## URGENT FIELD SAFETY NOTICE

### Neuroinspire Instructions for Use - Depth Offset Image Error

Renishaw Mayfield FSN Reference: VR-20-3

*Figure 2 - Correct image:*

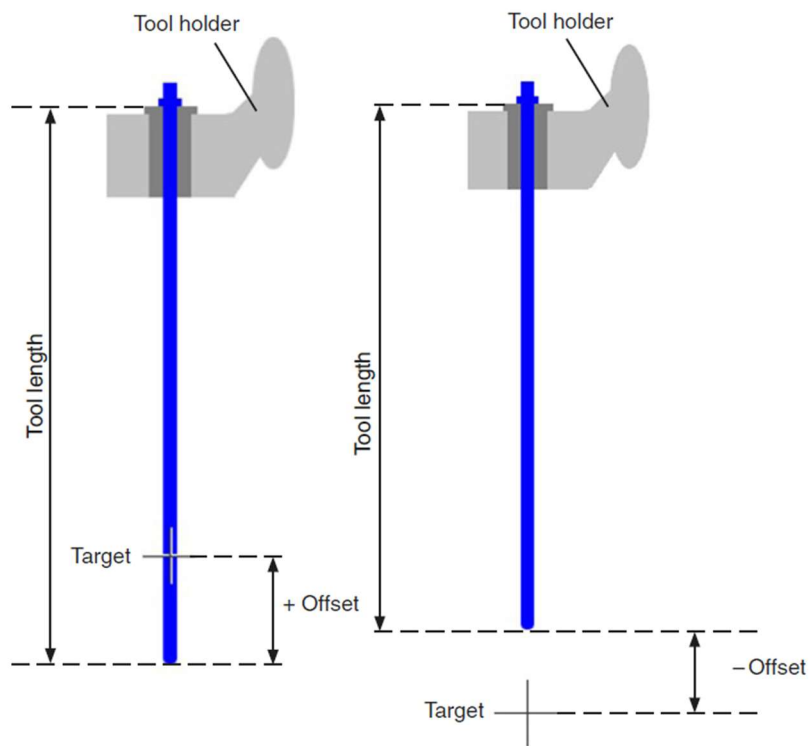
<p><b>AFFECTED PRODUCTS</b></p>	<p>Two Instructions for Use are affected:</p> <ul style="list-style-type: none"> <li>• Neuroinspire Neuromate Module Instructions for Use (H-5630-3016 versions A2-A6)</li> <li>• Plan Delivery USA Instructions for Use (H-5630-3050-A1)</li> </ul>
<p><b>PROBLEM DESCRIPTION</b></p>	<p>In Section <b>3.4 Move to Trajectory</b> of the Neuroinspire Neuromate Module Instructions for Use (H-5630-3016-A6) and the Neuroinspire Plan Delivery Instructions for Use (H-5630-3050 A1), the bottom right image (figure 1) showing a negative offset is incorrect. The horizontal dotted lines in the image have incorrectly shifted downwards in the image. The image (below, right) suggests that the tool length is taken from the top of the tool holder instead of the top of the guide bush.</p> <p><i>Figure 1 - Incorrect image:</i></p> <p><b>a.</b> The dotted lines are shifted on the bottom of the drawing; the tip of the tool does not touch the dotted line.</p> <p><b>b.</b> The datum point should be level with the guide bushing.</p> <p><b>c.</b> The dotted line should be level with the target</p>

<p>Please note that it is clearly written and repeated in the instructions that “the tool length is <u>always</u> measured from the back face of the guide bushing” / “the tool length is the distance from the back face of the guide bushing to the tip of the instrument” .</p> <p>All other images and text in the IFU confirm the correct instructions. Training provided to the clinician also informs the user that the tool length is measured from the back of the bushing.</p>
<p><b>HAZARD INVOLVED</b></p>	<p>The difference in position of the back of the tool holder and the back of the bushing from the target is 2mm.</p> <p>This is in conflict with the other information provided and could cause confusion to the user.</p> <p><b>First scenario:</b> User experiences confusion and surgeon then carries out a confirmatory check or request further assistance from Renishaw to determine if tool/implantable can be delivered to the correct depth. The confirmatory check by the surgeon would lead to potential increase of general anaesthetic exposure to the patient.</p> <p><b>Second scenario:</b> By using this incorrect datum position, the user could unintentionally create a 2mm positive offset from the intended position of the tool/implantable. Upon delivery, the tool/implantable would be positioned 2 mm beyond the distal end of the planned position. The resultant harm to the patient would range from minor damage to brain structures, to serious harm.</p> <p>As surgical planning should always consider the overall accuracy of the system and the nearby structures, users are unlikely to create plans with critical structures being <math>\leq 2</math> mm from the of the end of the tool/implantable. Also, the incorrect image highlights the negative offset where the tip of the tool is planned at a point short of the target. The likelihood that a clinician would plan a surgery with critical structures within this 2mm region is considered very low.</p> <p>Due to all additional information within the IFU being correct and the user-training provided, the likelihood of the user being aware of the need to account for this 2 mm difference is considered low. The user is most likely to question the conflicting information and carry out their own checks or raise it with Renishaw service staff rather than acting against the training received.</p>

<p><b>ACTION TO BE TAKEN BY CUSTOMER / USER</b></p>	<p>Please stop using the referenced Instructions for Use and take note of amendment/reinforcement of the correct image relating to negative offset requirements.</p> <p>Users are informed that the following image (figure 2) is now corrected and will soon be provided in an updated Instructions for Use. Users are informed that all consideration of tool length should be measured from <b>the back face of the bushing</b> in all cases and to contact Renishaw should they have any queries</p>
